**EASTERN CORRIDOR SEGMENTS II AND III  
Red Bank Corridor to I-275/SR 32 Interchange  
(PID 86462)**

**October 24 and 25, 2018 Public Open House  
CONCEPT EVALUATION and COMMENT SUMMARY**

February 2019

## ANCOR/SR HILL FOCUS AREA CONCEPTS C10 AND C11, BOARD 18

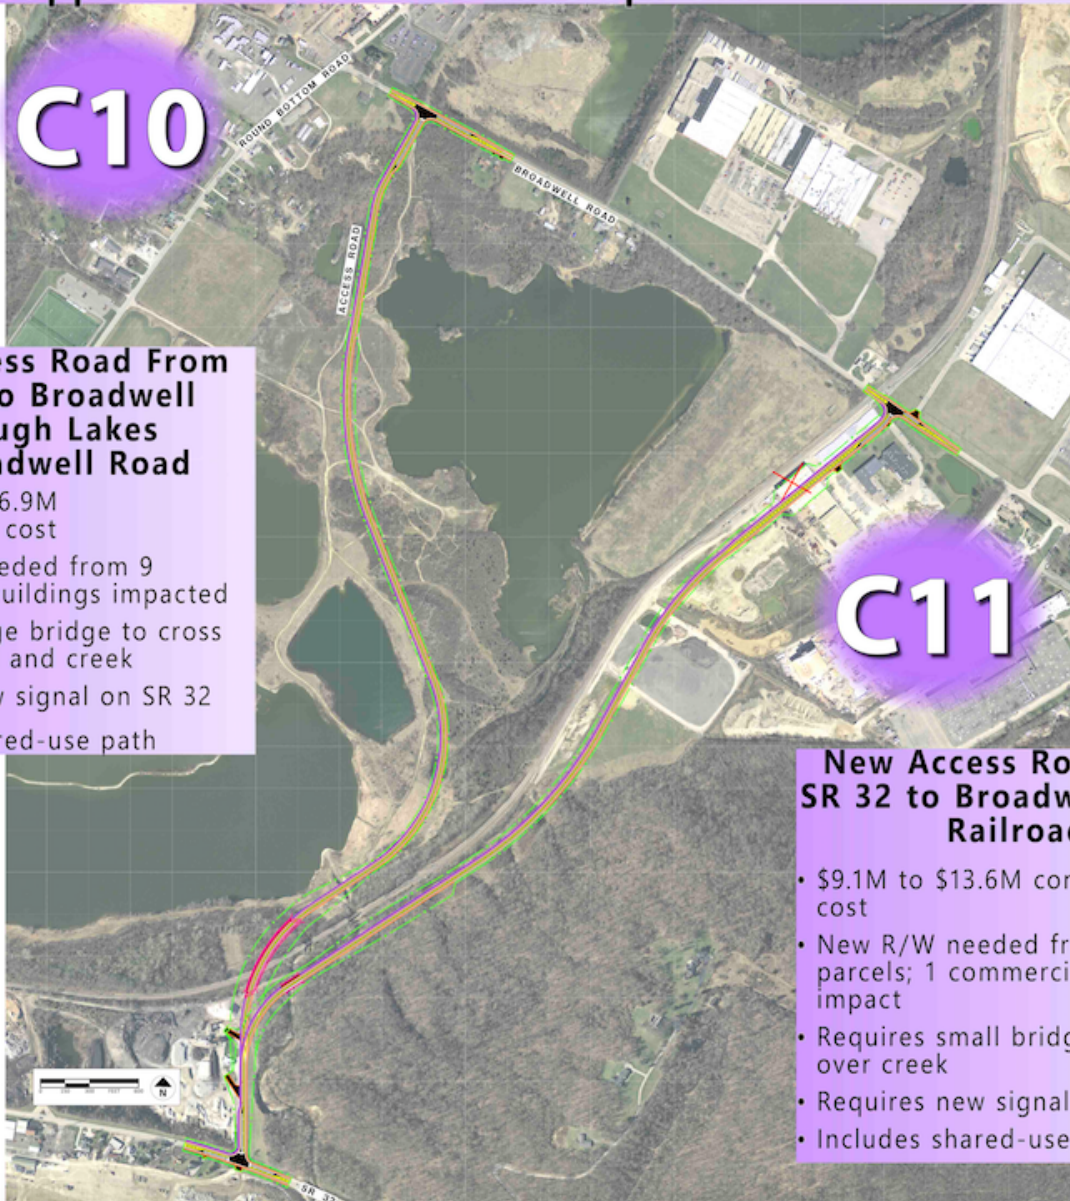
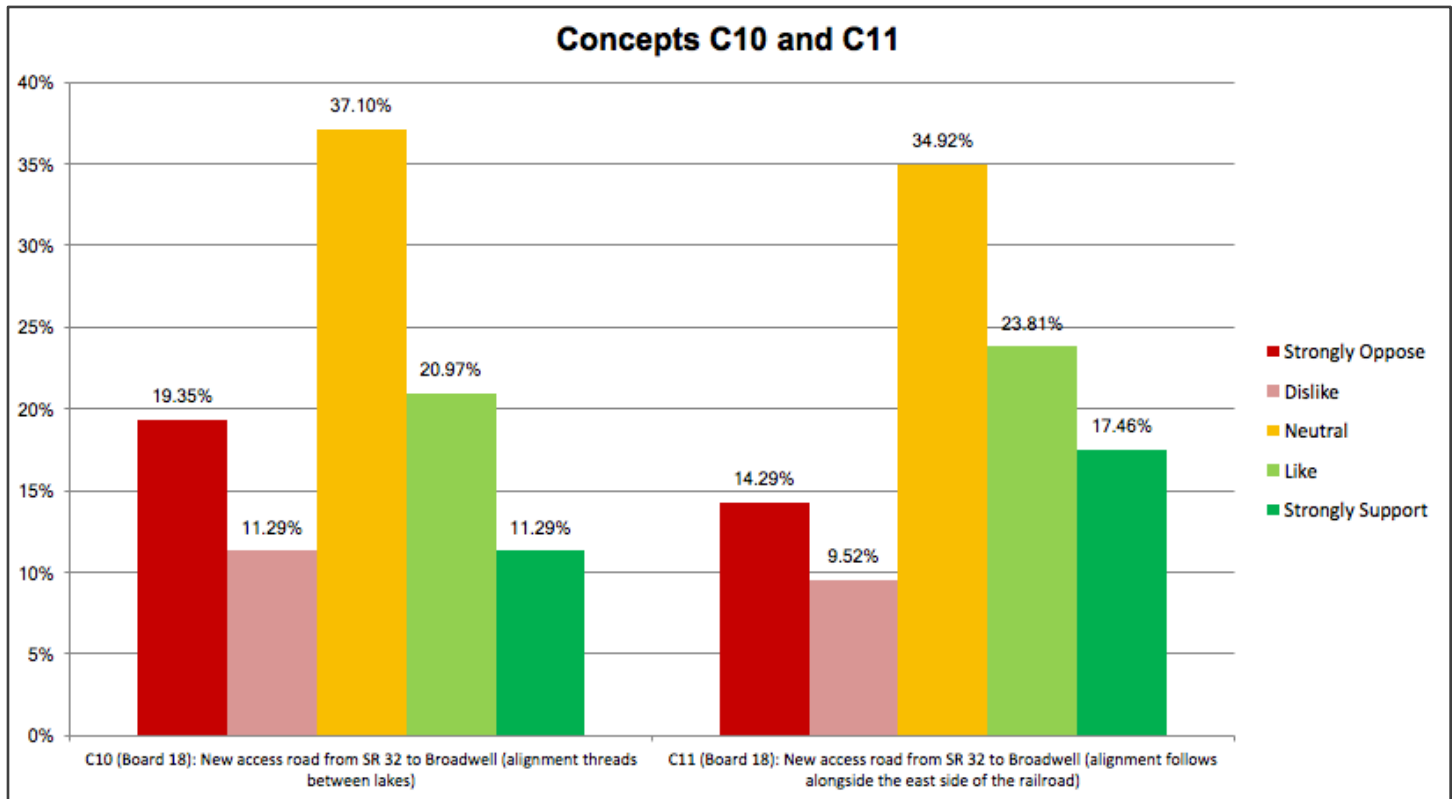
NO.	COMMENT	RESPONSE
1	I would be more interested in C10 & 11 if the mining and landscaping companies would offset the majority of the cost. At this point freight doesn't seem to be a huge problem but this could change if additional mining is planned.	Thank you for your comments. Your input is appreciated and will be taken into consideration as we evaluate the options and develop our recommendations.
2	Like trails on C10 AND C11	Thank you for your comment. Your input is appreciated and will be taken into consideration as we evaluate the options and develop our recommendations.

NO.	COMMENT	RESPONSE
1	I would be more interested in C10 & 11 if the mining and landscaping companies would offset the majority of the cost. At this point freight doesn't seem to be a huge problem but this could change if additional mining is planned.	Thank you for your comments. Your input is appreciated and will be taken into consideration as we evaluate the options and develop our recommendations.
2	Like trails on C10 AND C11	Thank you for your comment. Your input is appreciated and will be taken into consideration as we evaluate the options and develop our recommendations.
